# UNITED STATES PATENT AND TRADEMARK OFFICE

APPLICATION NO.	FILING DATE	FIRST NAMED INVENTOR	ATTORNEY DOCKET NO.	CONFIRMATION NO.
10/799,307	03/12/2004	Jae-Hyun Kim	8054L-50 (LW9007US/HJ)	8101
22150 7590 06/09/2010 F. CHAU & ASSOCIATES, LLC 130 WOODBURY ROAD WOODBURY, NY 11797			EXAMINER CHIEN, LUCY P	
			ART UNIT	PAPER NUMBER
			2871	
			NOTIFICATION DATE	DELIVERY MODE
			06/09/2010	ELECTRONIC

<b>Office Action Summary</b>	<b>Application No.</b> 10/799,307	<b>Applicant(s)</b> KIM ET AL.	
	<b>Examiner</b> LUCY P. CHIEN	<b>Art Unit</b> 2871

## **DETAILED ACTION**

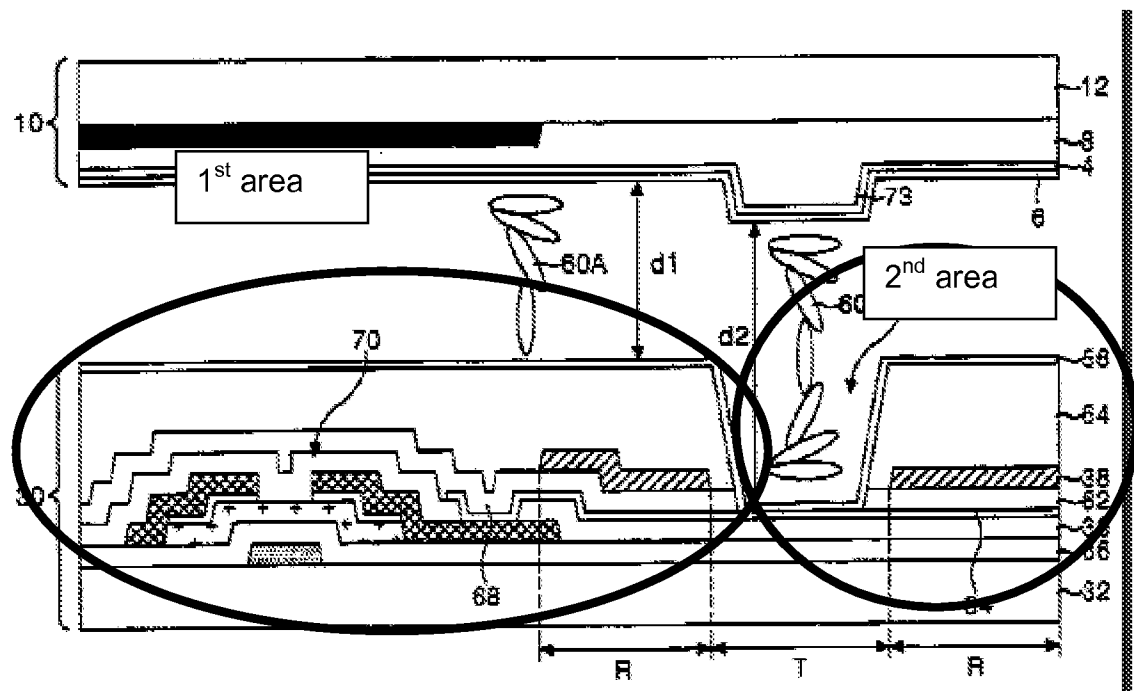
**Claim 8,35,40** are rejected under 35 U.S.C. 102(e) as being anticipated by Jin et al (US 6922219).

Jin et al (Fig 10) discloses a first substrate (32 having a first area (broad and can be interpreted to be anywhere, shown below) and a second area (shown below) a switching device (70) formed on the first substrate (32), a first insulating layer (36) formed on the switching device; a pixel electrode (34) formed on the first insulating layer

(36) and connected to the switching device (68), a second insulating layer (62) formed on the pixel electrode (34) and in the first area, a reflecting plate (38) formed on the second insulating (62) a second substrate (12) facing the first substrate (32); and a liquid crystal layer (60a) interposed between the first and second substrates; the reflecting plate partially overlaps (the reflector overlaps all the transparent regions to make it a reflective region, thus, overlaps with the second area. Second area also construed as the part where the reflector is not overlapping the D2 area) with the second area (shown circled below). The liquid crystal molecules rubbed along a predetermined direction (alignment film 56).

Jin (Fig. 10) discloses a third insulating layer (64) formed on the second insulating layer (62)

Jin (Fig. 10) discloses wherein the second substrate includes a color pixel (8) having a first thickness in the first area and a second thickness in the second area, and the first thickness is different from the second thickness (column 6, lines 30-37)

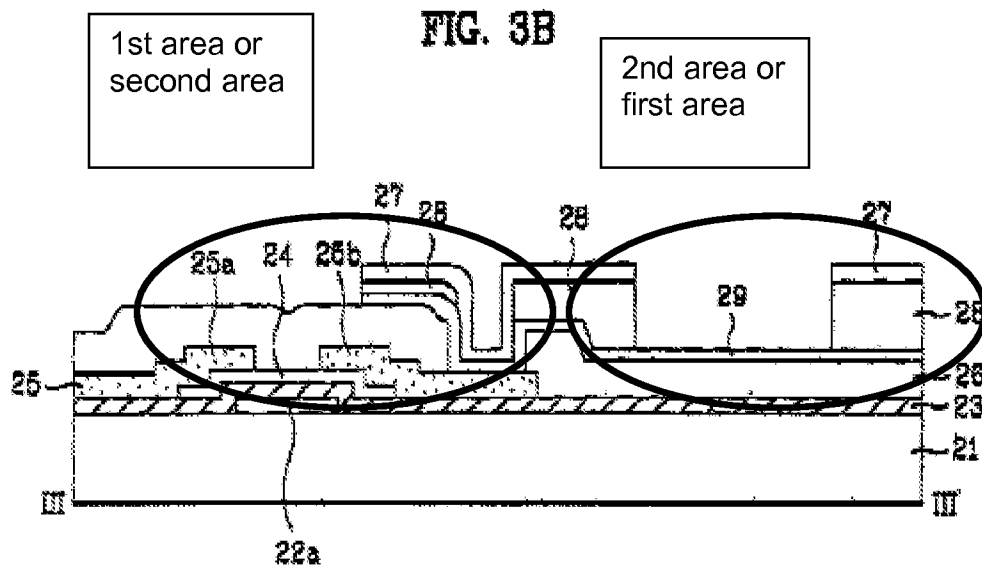
Kim et al (Fig 3b) discloses a first substrate (21) having a first area (broad and can be interpreted to be anywhere, shown below) and a second area (shown below) a switching device (22a) formed on the first substrate (21), a first insulating layer (26) formed on the switching device; a pixel electrode (29) formed on the first insulating layer (26) and connected to the switching device (25b), a second insulating layer (28) formed on the pixel electrode (29) and in the first area, a reflecting plate (27) formed on the second insulating (28) a second substrate ([0006]) facing the first substrate (21); and a liquid crystal layer ([0006]) interposed between the first and second substrates; the

reflecting plate partially overlaps (the reflector overlaps all the transparent regions to make it a reflective region, thus, overlaps with the second area) with the second area (shown circled below,).

In addition to Kim et al and Ha as disclosed above, Kim et al (Fig. 3b) discloses wherein the pixel electrode (29) is electrically connected to the switching device (25b) through a contact hole that is formed through the first insulating layer (26).

In addition to Kim et al and Ha as disclosed above, Kim et al (Fig. 3b) discloses wherein a portion of the reflecting plate (27) makes contact with the pixel electrode (29) in the second area (shown above, the reflecting plate contacting the pixel electrode to contact the drain (25b)).

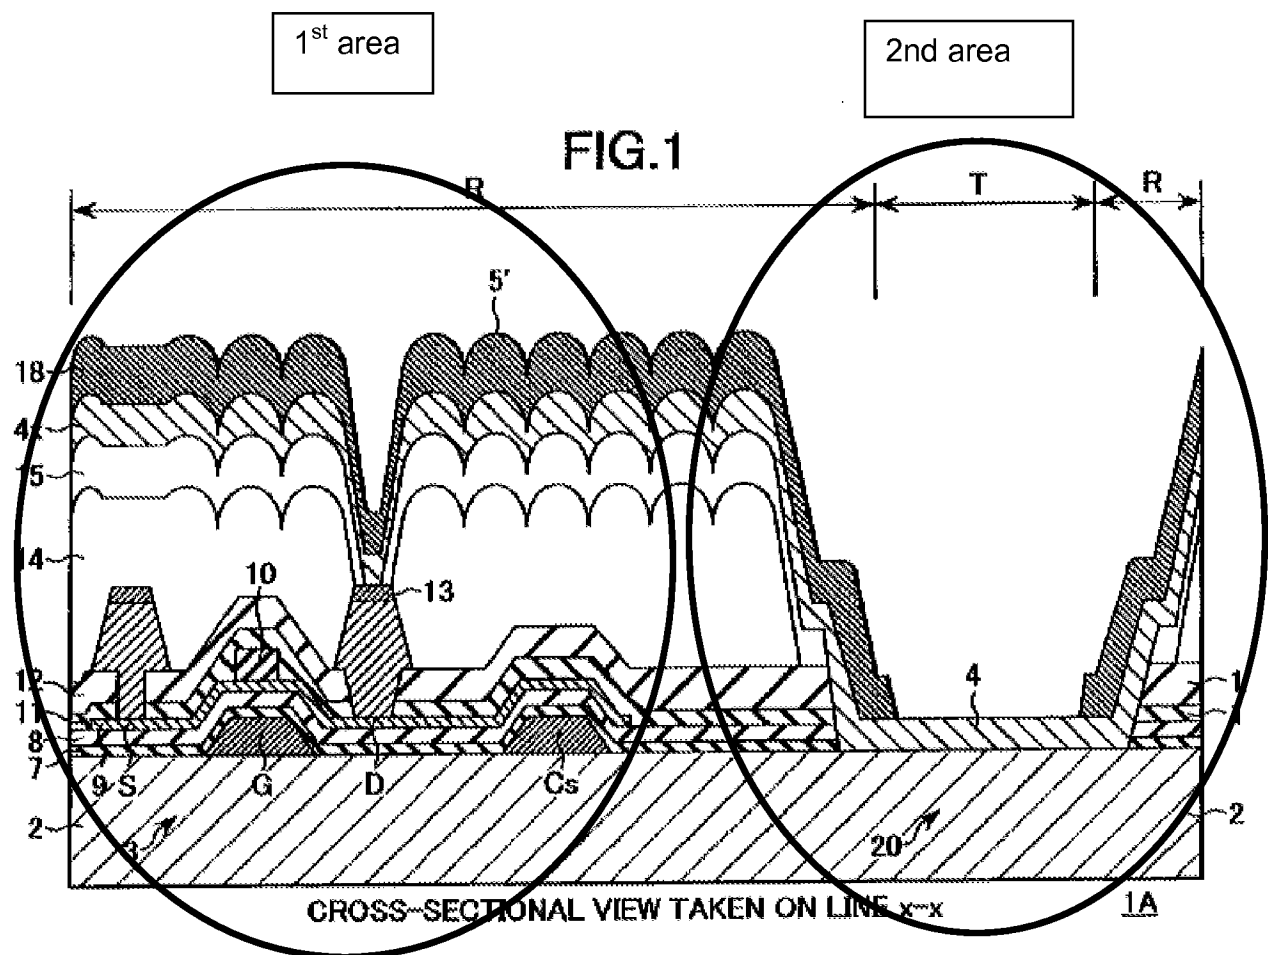
Shigeno et al discloses (Fig. 1) a substrate (2) having a first area (very broad and be construed as anywhere, circled below) and a second area (very broad, and can be construed as being anywhere, see figure below) a switching device (G,D,S) formed on the substrate (2); a first insulating layer (12) formed on the switching device; a second insulating layer (14) formed on the first insulating layer (12) and in the first area; a pixel electrode (4x) formed on the first insulating layer (12) and connected to the switching device (D,13); a third insulating layer (15) formed on the second insulating layer (14); and a reflecting plate (18) formed on the third insulating layer (15), wherein the reflecting plate is formed in the first area (shown below).

Shigeno et al discloses (Fig. 1) wherein a portion of the reflecting plate is formed in the second area (T).

Shigeno et al discloses (Fig. 1) wherein a portion of the third insulating layer is formed in the second area (shown above).

Shigeno et al discloses (Fig. 1) wherein the pixel electrode (4x) is electrically connected to the switching device (13) through a contact hole that is formed through the second insulating layer (14).
